Access Compliance Report Public Rights-of-Way (Pedestrian Signals)

Main Street: **BEACH_BLV** Cross Street: **MCFADDEN_AVE** Location: **SW**

ADA ID: **SGRK211005145056** Signal Type: **One Push Button-APS** Overall Compliance: **No** Severity Scores: **BTN 1: 25** **BTN 2: N/A** **No BTN: N/A**

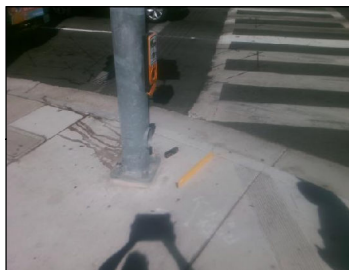
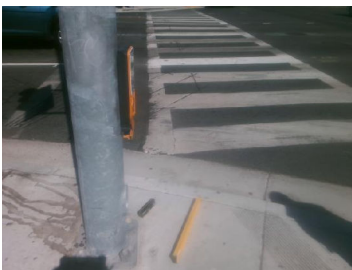
OC Std/PROW: **R404.2**

Possible Solutions: Remove and Replace Clear Space.
